City of Sugar Hill  
Planning Staff Report  
RZ 16-002

**DATE:** June 28, 2016  
**TO:** Mayor and City Council  
**FROM:** Planning Director *KA*  
**SUBJECT:** Change in Conditions RZ 16-002 – Bellagio Properties

RE: Proposed Grocery Store by Bellagio Properties  
RZ 16-002  
W&A Job Number 16-CE-008

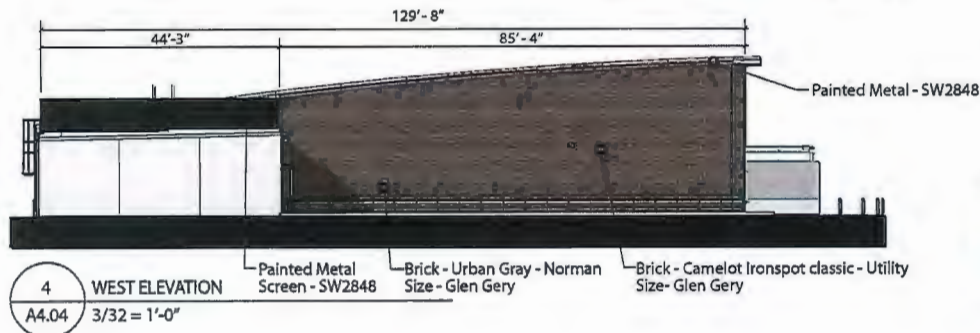
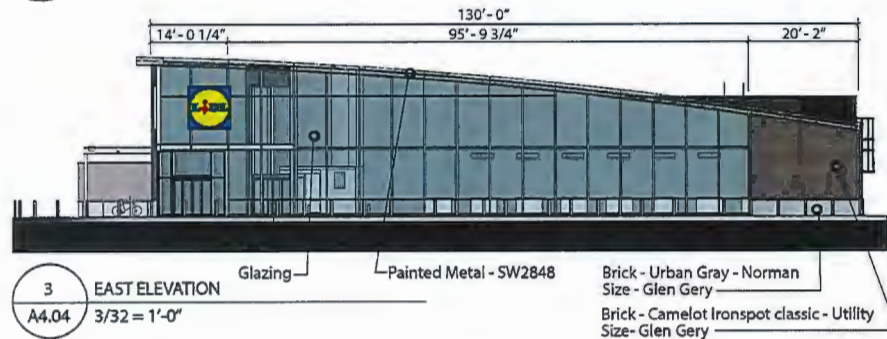
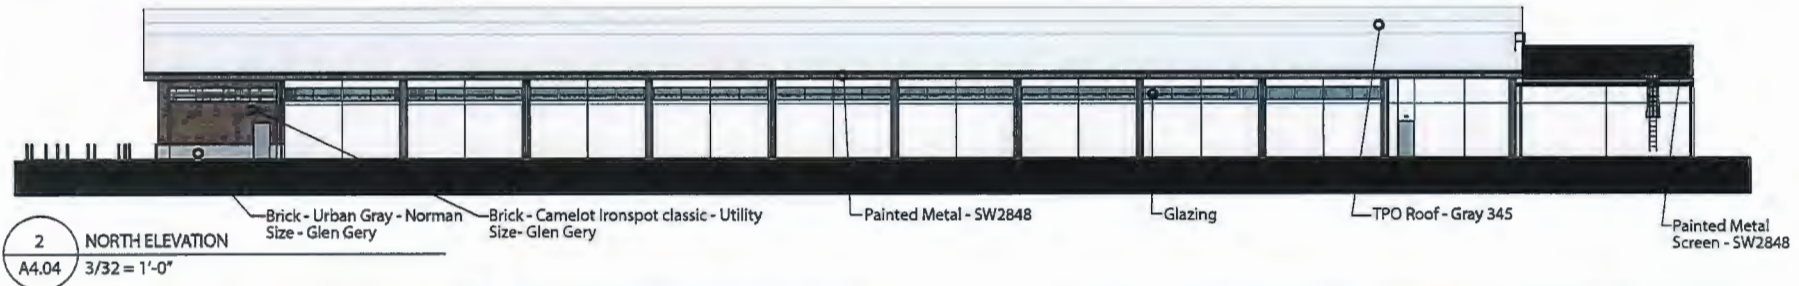
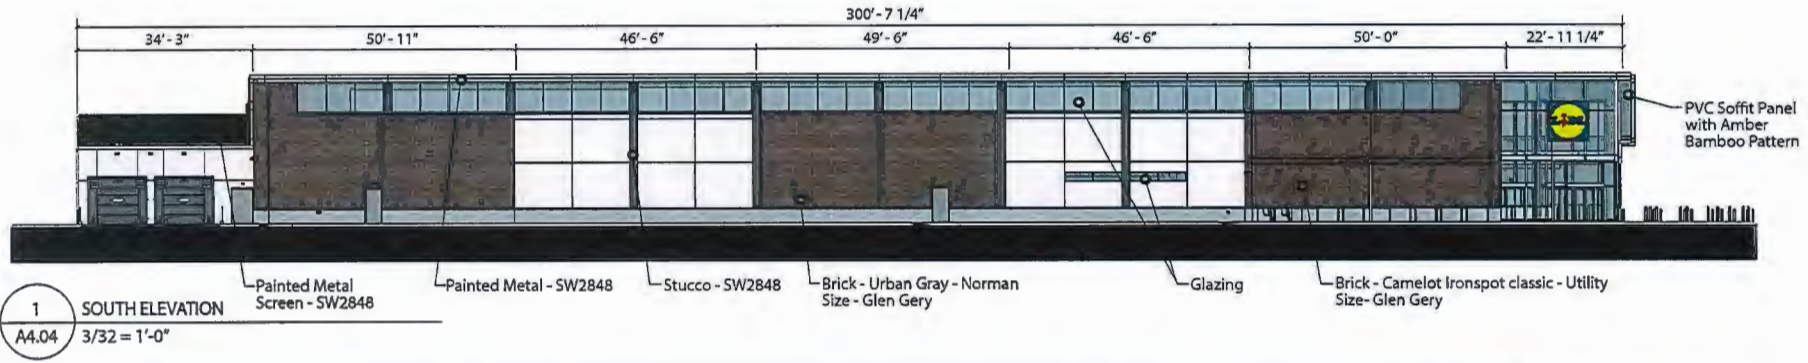
- More than two primary building materials have been used (from Sugar Hill Zoning Ordinance, page 6.9, "With the exception of accent/trim materials, there shall be no more than two primary building materials used.")

- Use of a glass curtain wall (from Sugar Hill Zoning Ordinance, page 6.9, "Mirrored glass with a reflection greater than 20% and glass curtain walls shall be prohibited.")

- Use of a façade segment greater than allowed. On both the east and west elevations, the total length of the façade is approximately 130'. An unbroken brick facade segment that is 85'-4" in length has been used on the west elevation, and an unbroken glass façade that is 95'-9 3/4" has been used on the east elevation (from Sugar Hill Zoning Ordinance page 6.9, "Building facades shall be visually divided into segments through articulation of the façade achieved by methods such as, but not limited to, variation in building materials, roof line, building setback, the use of additional window bays, pilasters, etc." The chart on this page shows that for 50'-150' length facades, the maximum segment length is 50')

- Staff has additional concerns regarding the quality of the building elevations presented.
  - The overall horizontality of the building elements (clerestory windows, column bays, change in materials, etc) and lack of architectural elements on the pedestrian level does not relate well to a human scale.

- Overall, the building lacks substantially in ornamentation and detail. At the pedestrian level, the façade is mostly blank with very few windows or architectural detailing to attract interest (from Sugar Hill Zoning Ordinance, page 6.9, “These guidelines shall foster architectural diversity and interest, yet achieve and maintain a consistent, durable and pleasing aesthetic/visual quality.”)

- The building does not display a clear hierarchy between service space and served (public) space. Due to the siting of the building on a corner lot, there are effectively two front facades (south and east). The south elevation (facing SR 20) includes a loading dock, service doors, and clerestory windows with a small amount of glazing located around 8-10’ height). The east elevation is primarily composed of a curtain wall. (from Sugar Hill Zoning Ordinance, page 10.12, “...utility/service areas shall be screened and incorporated into the design of the building and/or hidden from public view when viewed from any public space or street level.” And from Sugar Hill Zoning Ordinance, page 6.6 “Roll-up type cargo bay doors shall be limited to the side or rear of buildings located in OI, HSB, and BG zoning districts.”)

- The stucco elements on the south elevation appear to read as columns; however, they do not penetrate the Urban Gray brick to the ground and in several locations are only located on the clerestory window portion and therefore appear to read as joists. The spacing and regularity between these two elements are not regular, and the function and/or aesthetics of these architectural elements are unclear. (from Sugar Hill Zoning Ordinance, page 6.6, “Each building design shall be made up of a compatible combination of these traditional architectural elements or similar elements...prominent columns, posts, and/or pilasters...”)

- As these stucco elements and joints in brick walls do not effectively divide the building into segments, this does not appear to meet the intent or spirit of the requirement within the zoning ordinance to visually divide facades into segments.

The issue with the building materials is the use of stucco. We are proposing to utilize more brick to break up the stucco along the side of the building facing SR 20. Considering the ordinance does not specifically address buildings over 30,000 SF in the BG zoning classification, we would ask for your consideration of these changes.

4. ~~Stucco, E.I.F.S, tilt/pre-cast, split face block & concrete block shall be prohibited as an exterior building material.~~ *Building materials match the building elevation prepared by BRR dated June 3, 2016.*

**Z-1**

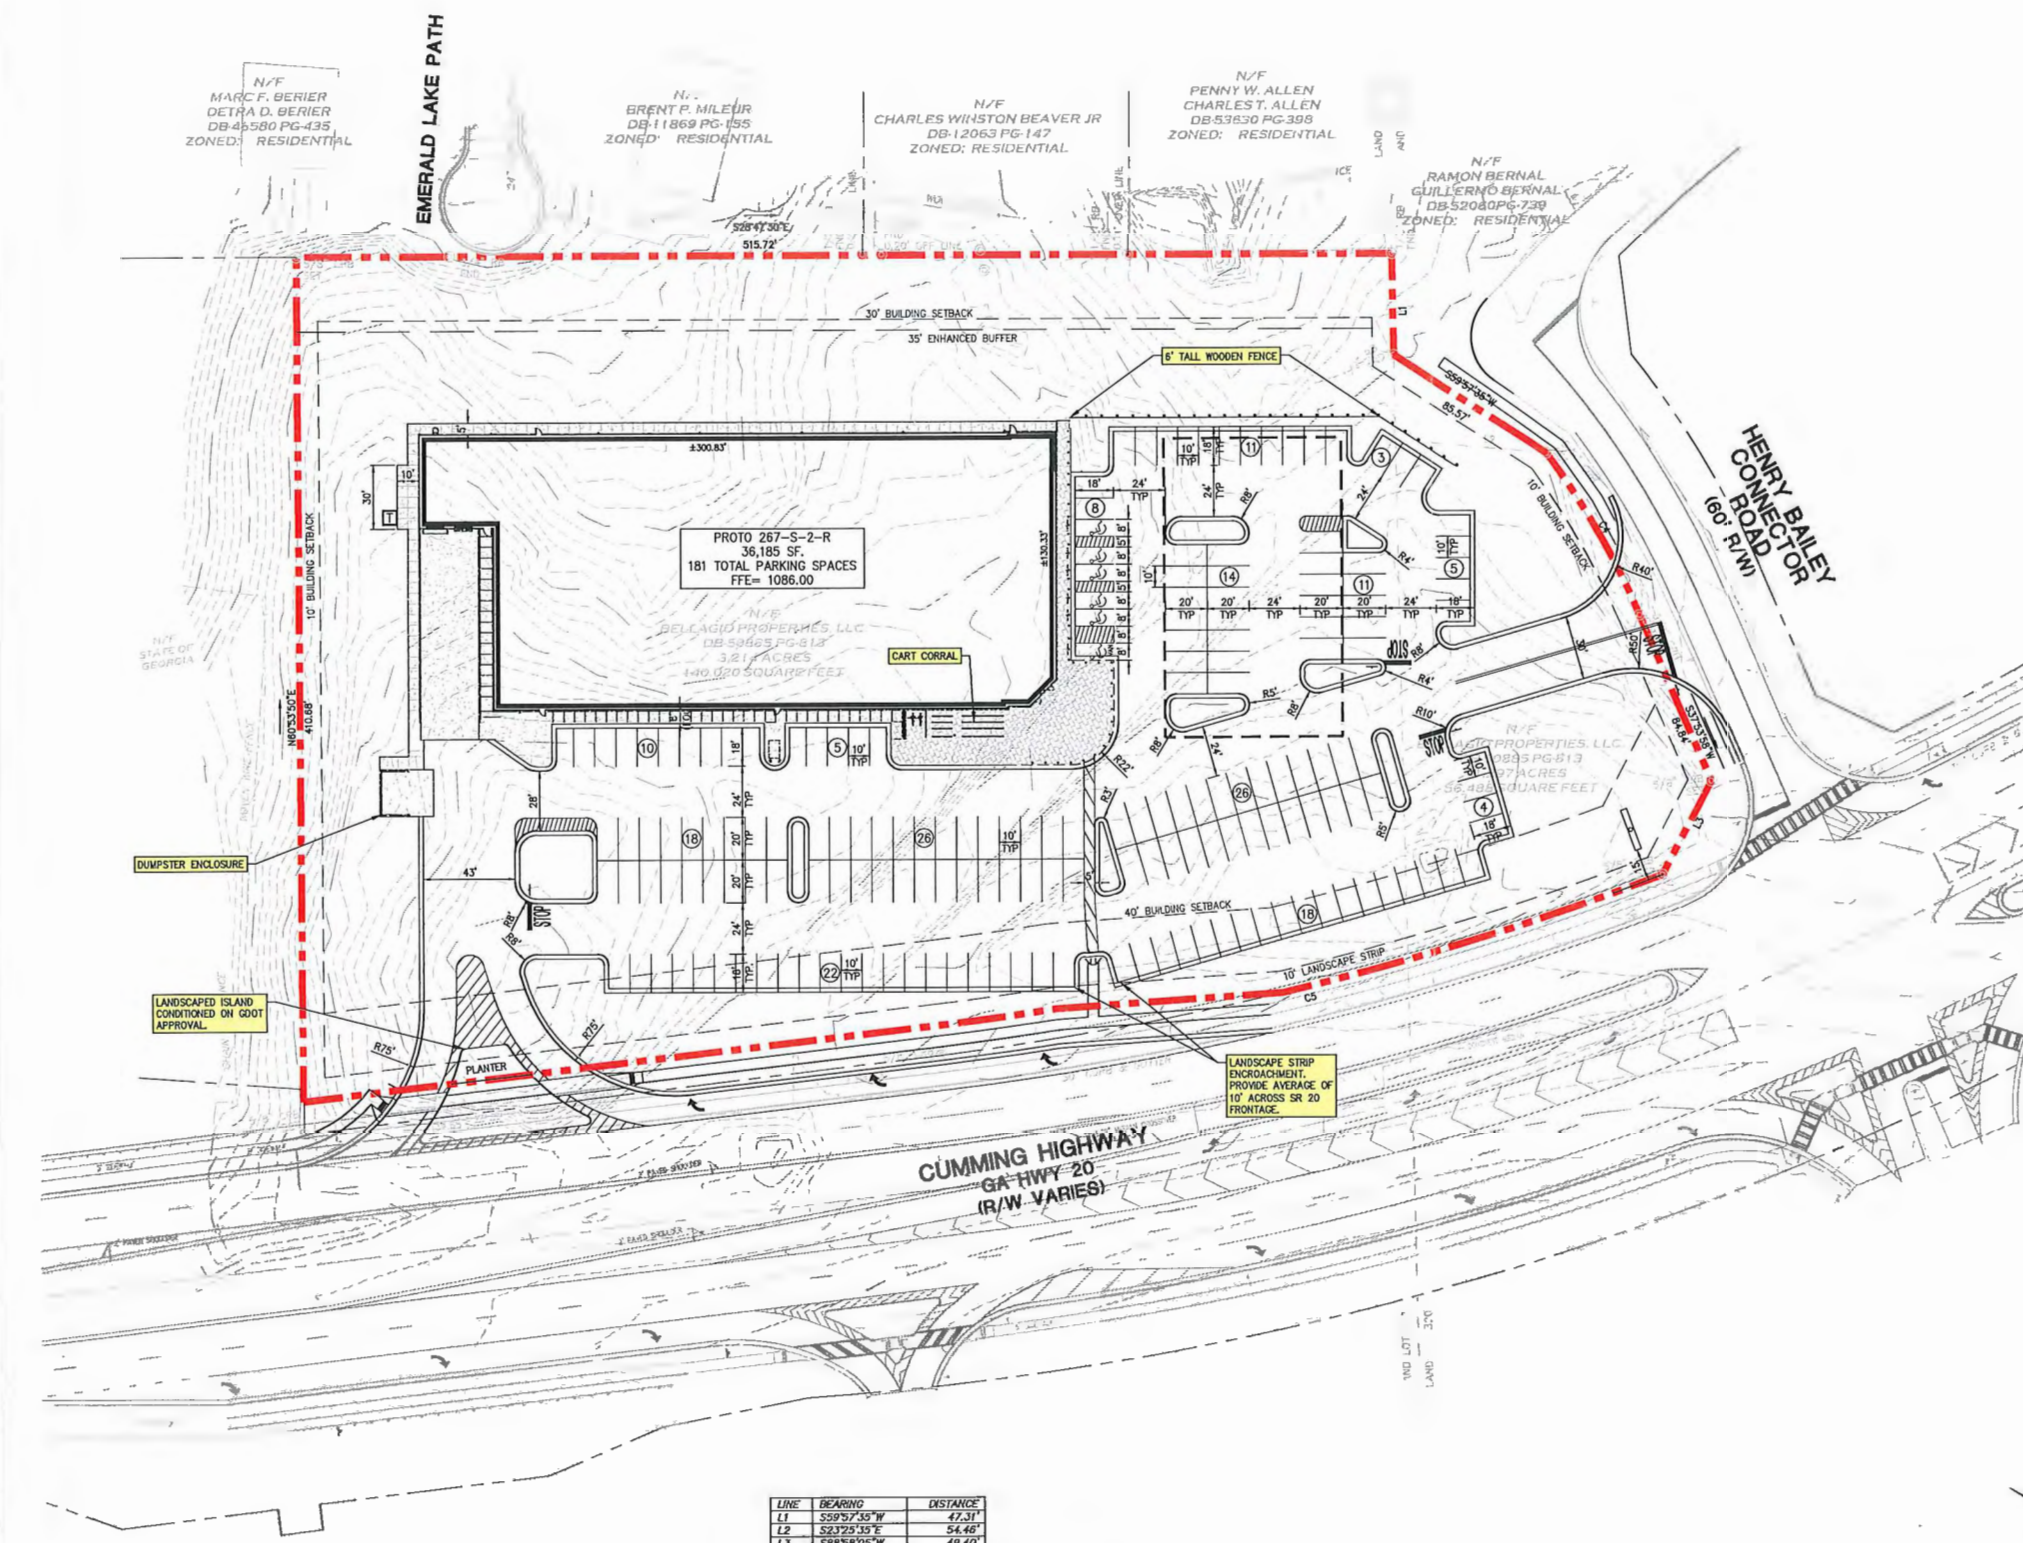
- The location of the loading dock and dumpster do not meet the zoning ordinance requirements and face SR 20 and the front driveway entrance to the parking lot.

As we discussed, the issue with the loading dock and dumpster locations is their visibility to SR 20. From a noise perspective, it is our opinion that the current location is best suited to minimize the impact on the adjacent residences. Given the volume of vehicles on SR 20 and the noise associated with those vehicles, the noise impact from the dumpster and loading dock to the properties south of SR 20 should be minimal.

To address the aesthetics, the site plan has been changed to create larger landscaped areas around the perimeter of the Right-in/Right-out driveway and within the parking lot. Additionally, we are proposing to landscape the portion of the island within the Right-in/Right-out driveway that is outside GDOT's right-of-way with the condition that GDOT approves it. It is our opinion that the combination of the dumpster enclosure and the additional landscaping will substantially screen both the dumpster and the loading dock from SR 20.

5. *The location of the dumpster enclosure and loading dock are approved per the site plan by W&A dated 6/3/16 provided the approval of the Landscape Plan by David Albright, dated 6/8/16.*
